Atty Docket No.: JCLA11476-R

Serial No.: 10/695,018

REMARKS**Present Status of the Application**

Discussion of Drawings Objection

Annotated Marked-up drawing**FIG. 1A (PRIOR ART)****FIG. 1B (PRIOR ART)**

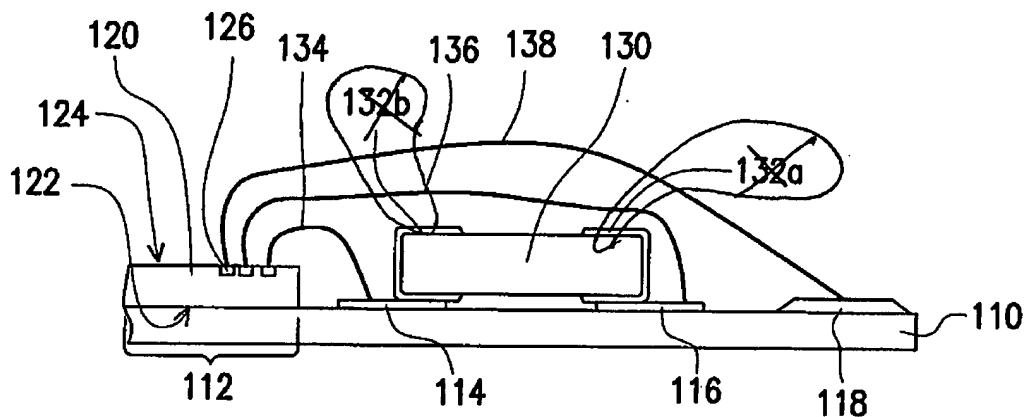
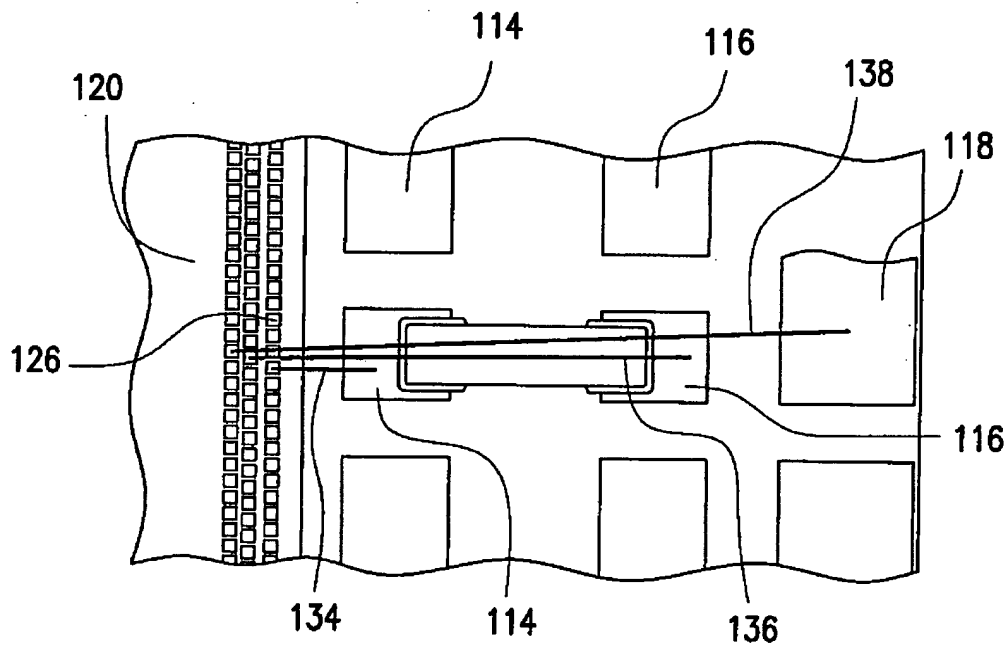
Figures 1B and 2B are objected to as failing to comply with 37 CFR 1.83(a) because they show inconsistent dispositional relationships between the passive component and the electrodes 132b and 232b and it is not clear whether the electrodes are at the top end of the passive element or at the sides thereof.

In response thereto, Applicants have amended Figures 1A, 1B, 2A, and 2B to clarify the dispositional relationships between the passive component and the electrodes 132b and 232b and to clarify that the electrodes are at the top end and bottom end of the passive element. Withdrawal of the objection is respectfully requested.
